APPLICATION FOR PERMISSION
UNDER SECTION 16 OF
THE TOWN PLANNING ORDINANCE
(CAP.131)

A/TM-SKW/121

Proposed Temporary Place of Recreation, Sports or Culture (Hobby Farm) for a Period of 3 Years and Excavation of Land

Figure 4

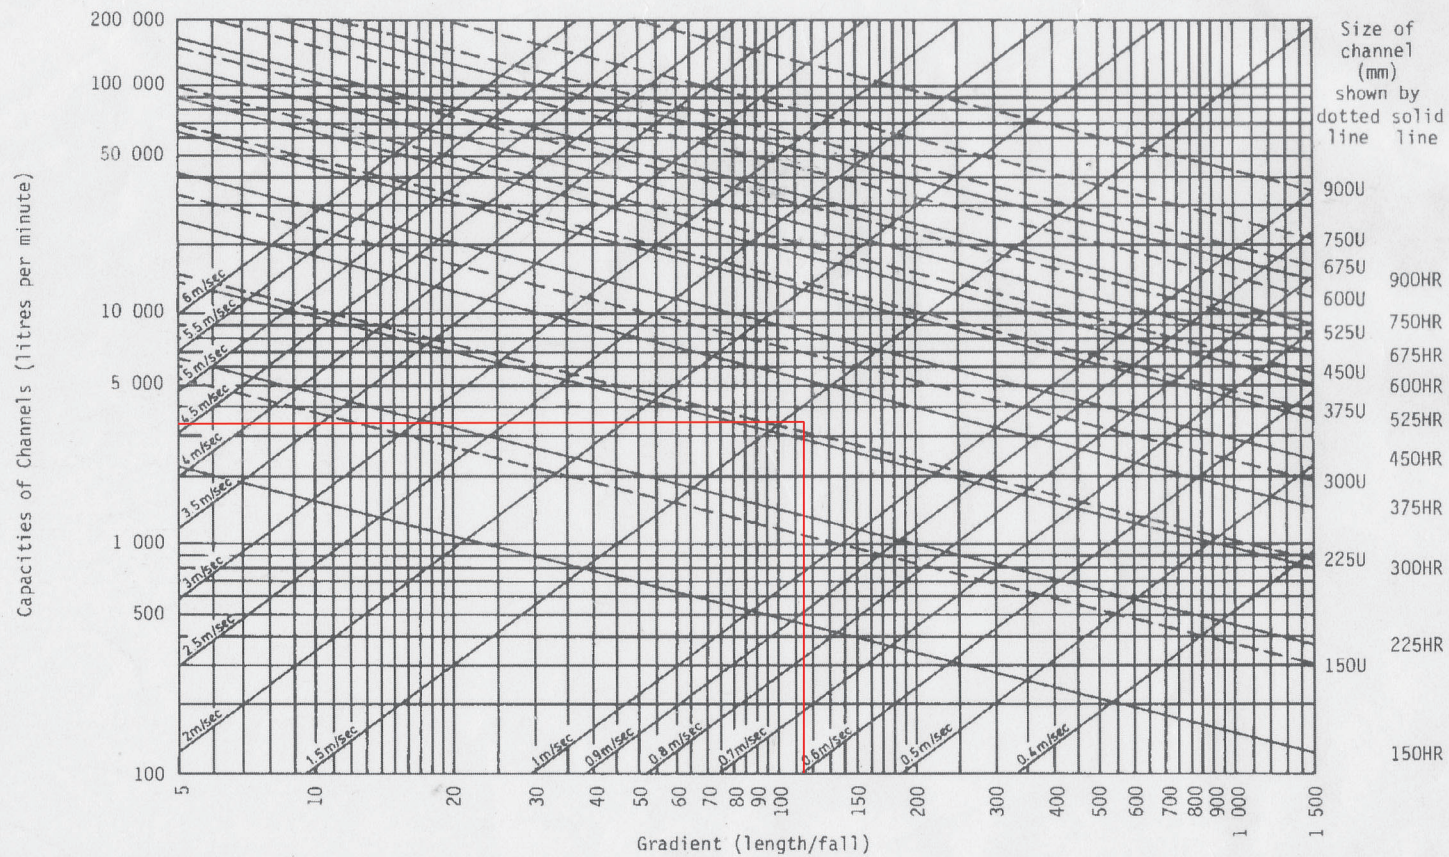
CE/MN, DSD's comments	Applicant's response
(i) Referring to figure 4, the size of existing underground pipe which is 375mm, is inconsistent with that as stated in para. 1.3.1 of Drainage proposal (i.e. 300mm). Please clarify.	Para. 1.3.1 has been updated. The applicant now proposes to connect with the existing 375mm surface channel connecting to the proposed terminal catchpit at the subject site in order to connect to the public drain as shown in the updated drainage plan. Para.1.3.1 should be read as below: 1.3.1 Subject to the calculations in 1.2 above, it is determined that proposed 300mm surface U-channel along the site periphery is adequate to intercept storm water passing through and generated at the application site (Figure 4). An existing 375mm surface channel is available to connect to the proposed terminal catchpit at the subject site in order to connect to public drain to the east.

(ii) The chart of Rapid Design of Channels is missing in the Drainage proposal.	Noted and please refer to the attachment.
(iii) There is no formal record of existing 375mm underground pipe and 375mm u-channels to which the proposed u-channels to be connected. The applicant is required to provide evidence to demonstrate its presence and to indicate its full alignment up to a well established streamcourse/ public drainage system.	Noted. The applicant now proposes to connect to the existing 375mm surface channel connecting the proposed terminal catchpit at the subject site. The existing 375mm surface channel connects to the public drain as shown in the proposed drainage plan in the attachment. Photos are attached below to show the presence of the existing 375mm surface U-channel.
(iv) The hydraulic calculation to demonstrate the existing drains are capable for taking the discharge from the site is missing.	The existing 375mm surface channel connecting the terminal catchpit of the subject site is solely provided to dissipate the stormwater intercepted at the subject site. As such, it would be capable for dissipating the stormwater intercepted at the subject site.

Figure 4

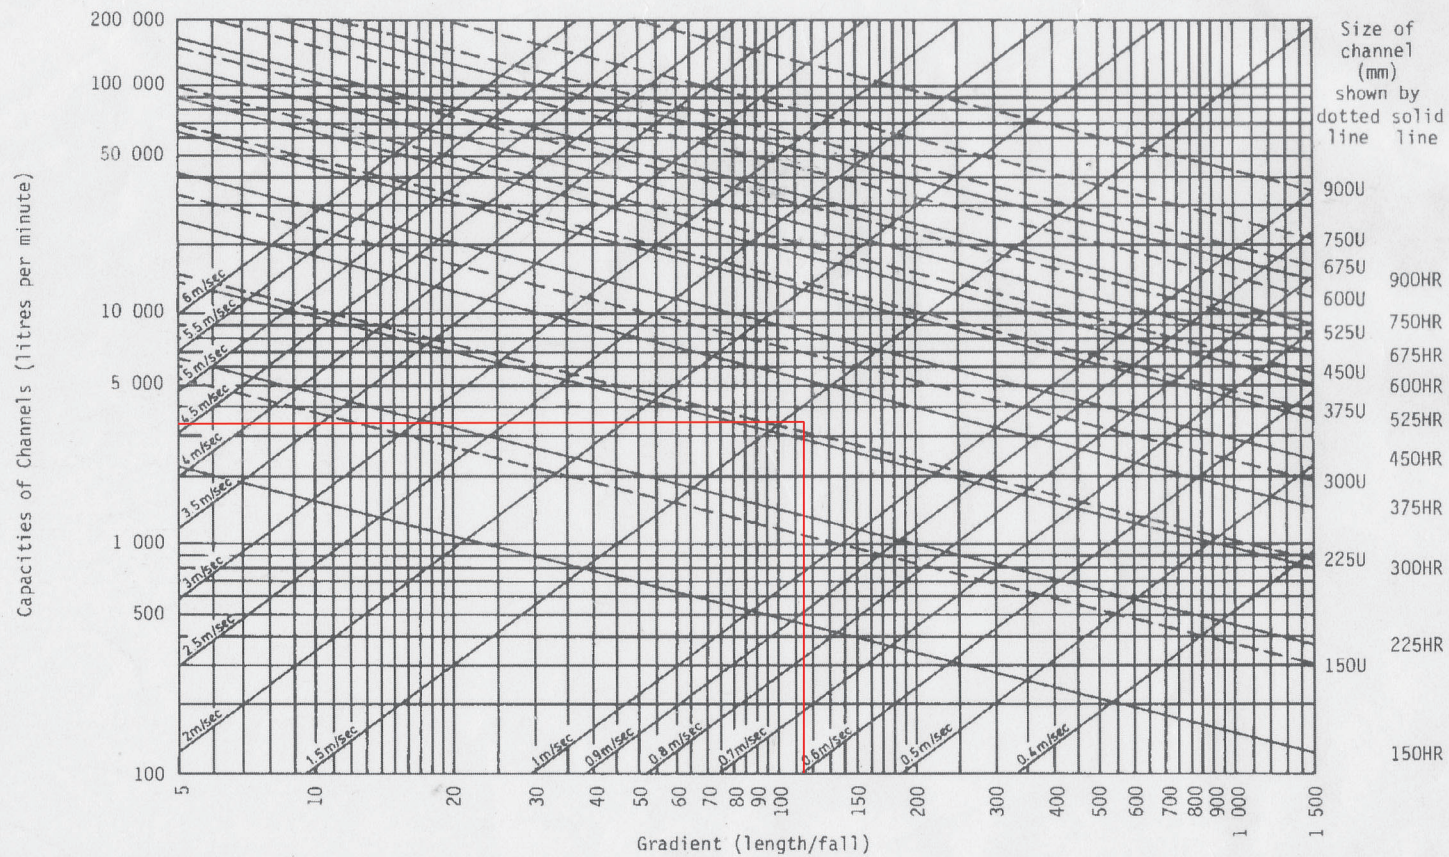
CE/MN, DSD's comments	Applicant's response
(i) Referring to figure 4, the size of existing underground pipe which is 375mm, is inconsistent with that as stated in para. 1.3.1 of Drainage proposal (i.e. 300mm). Please clarify.	Para. 1.3.1 has been updated. The applicant now proposes to connect with the existing 375mm surface channel connecting to the proposed terminal catchpit at the subject site in order to connect to the public drain as shown in the updated drainage plan. Para.1.3.1 should be read as below: 1.3.1 Subject to the calculations in 1.2 above, it is determined that proposed 300mm surface U-channel along the site periphery is adequate to intercept storm water passing through and generated at the application site (Figure 4). An existing 375mm surface channel is available to connect to the proposed terminal catchpit at the subject site in order to connect to public drain to the

east.
(ii) The chart of Rapid Design of Channels is missing in the Drainage proposal.	Noted and please refer to the attachment.
(iii) There is no formal record of existing 375mm underground pipe and 375mm u-channels to which the proposed u-channels to be connected. The applicant is required to provide evidence to demonstrate its presence and to indicate its full alignment up to a well established streamcourse/public drainage system.	Noted. The applicant now proposes to connect to the existing 375mm surface channel connecting the proposed terminal catchpit at the subject site. The existing 375mm surface channel connects to the public drain as shown in the proposed drainage plan in the attachment. Photos are attached below to show the presence of the existing 375mm surface U-channel.
(iv) The hydraulic calculation to demonstrate the existing drains are capable for taking the discharge from the site is missing.	The existing 375mm surface channel connecting the terminal catchpit of the subject site is solely provided to dissipate the stormwater intercepted at the subject site. As such, it would be capable for dissipating the stormwater intercepted at the subject site.

Our response to the further comments of the CE/MN, DSD is as follows. The para 1.3.1 has been updated in the updated report in the attachment.
